**MONTGOMERY COUNTY HISTORIC PRESERVATION COMMISSION**  
**STAFF REPORT**

<b>Address:</b>	17715 Meeting House Road, Sandy Spring	<b>Meeting Date:</b>	3/6/2024
<b>Resource:</b>	<b>Sandy Spring Meeting House</b> (Master Plan Historic Site 28/011-001A) <b>Sandy Spring Historic District</b> (Master Plan Site No. 28/11)	<b>Report Date:</b>	2/28/2024
<b>Applicants:</b>	Sandy Spring Monthly Meeting (Miche Booz, architect)	<b>Public Notice:</b>	2/21/2024
<b>Review:</b>	HAWP	<b>Tax Credit:</b>	N/A
<b>Permit No.:</b>	1057575	<b>Staff:</b>	Chris Berger
<b>Proposal:</b>	Porch alterations

Sandy Spring Monthly Meeting  
Meeting House Repair and Porch Alteration  
17715 Meetinghouse Road  
HAWP #1057575

*Figure 3. The central concrete stair proposed for replacement is evident in this photo. The concrete steps also proposed for replacement are visible to either side.*

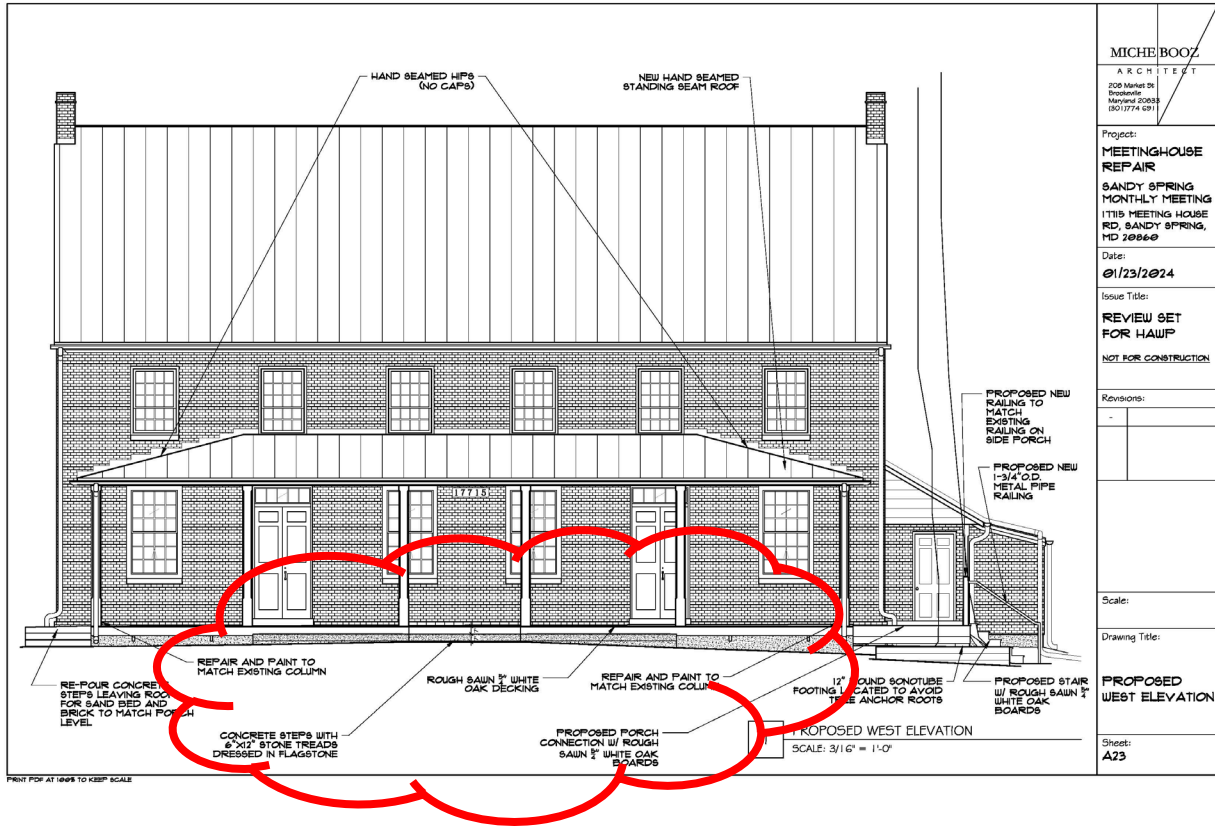
Staff supports replacement of the concrete steps and stairs with concrete steps with stone threads at the front porch along Meeting House Road and recommends approval (*Figures 2-4*). There currently are a pair of approximately 12-foot long single steps to either side of the approximately 8-foot long concrete central stair. The central stair has two threads and two risers symmetrically placed between two porch columns. The applicant will replace all the concrete steps and stair with concrete stairs topped with 6-by-12-inch flagstone. Staff seeks a condition that the applicant provide a stair detail for this work item.

1. The applicant shall provide staff with a detail for the stone stairs to be installed at the front porch along Meeting House Road to replace the concrete steps and stair.
2. The proposed alterations to Meeting House Road are not approved and shall be reviewed as part of a separate HAWP after approval from the Montgomery County Department of Transportation and Rustic Roads Advisory Committee.
3. The applicant shall provide staff with specifications for the railings, stone stair threads, standing seam roof, and brick pavers.
4. The replacement standing seam roof shall closely match the existing in design and seam width. Snowbirds shall also be installed on the new roof.
5. The applicant shall provide staff with plans for the replacement pipe railings to be installed at the north end of the front porch.

Figure 8. The proposed connecting deck and new stair and railing are clouded in red.

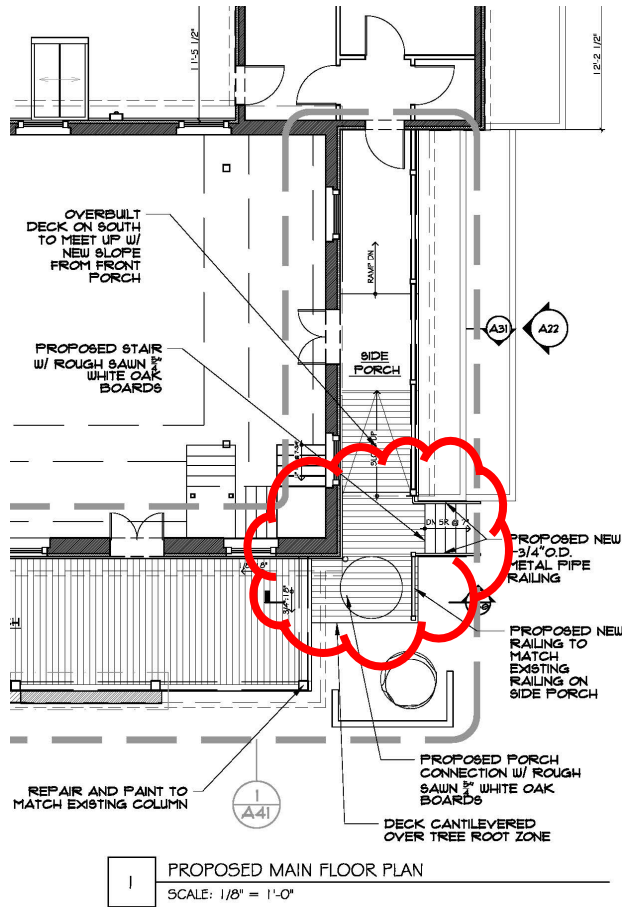
Staff supports the construction of a deck to connect the front and south porches and new stair at the south porch and recommends approval (*Figures 6-10*). The applicant provided archival photos of the building that show a wraparound deck that linked the front and south porches. It is unknown when the deck section was removed. According to the applicant, wheelchair users must pass through the church in order to reach the restrooms at the south porch. The applicant proposes to demolish the concrete stairs at the south end of the front porch and west end of the south porch to build a wood deck to connect the two porches. A Sonotube footer will support the decking to minimize the potential effect to the root zone of the nearby sycamore tree. A new wooden stair with pipe railings will be installed perpendicular to the south porch. Both the decking and stairs will be built of rough sawn oak to match the existing decking. A pipe railing will be installed at the south end of the deck extension to match the design of the railing present on the south porch.

Figure 12: This plan shows the proposal to remove the concrete pad and replace the concrete stair clouded in red.

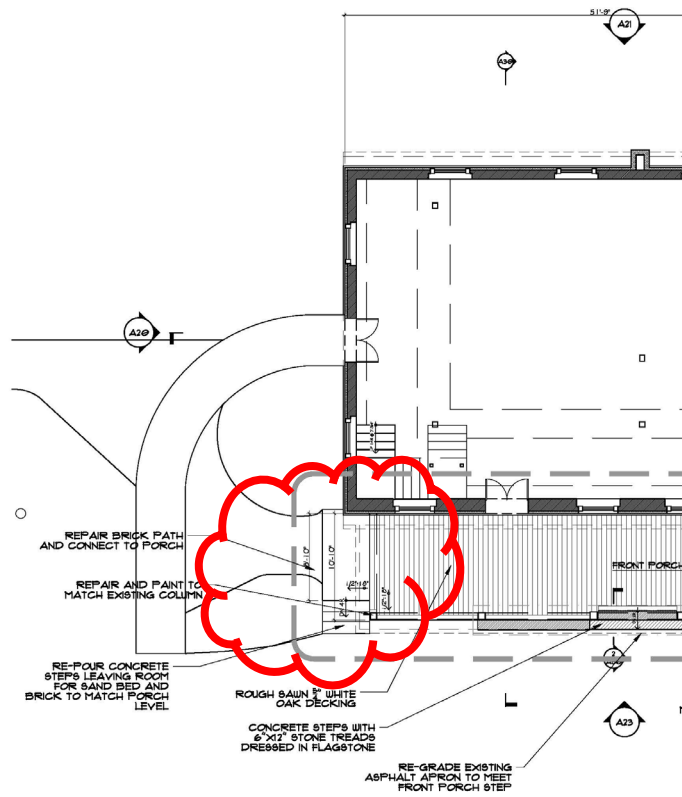
Staff supports replacement of the concrete pad and concrete stairs at the north end of the front porch and recommends approval (Figures 11 and 12). According to the applicant, the existing concrete pad and stairs are unlevel where they meet the wood porch decking. The applicant proposed to remove the concrete pad and replace it with a bed of sand and red bricks that match the current brick walkway and be level with the porch floor. The applicant seeks to pour concrete steps. In the project narrative, the applicant noted the existing pipe handrails will be replaced, but the railings are not evident on the plans, so staff seeks a condition that the applicant show the railings on the plans.
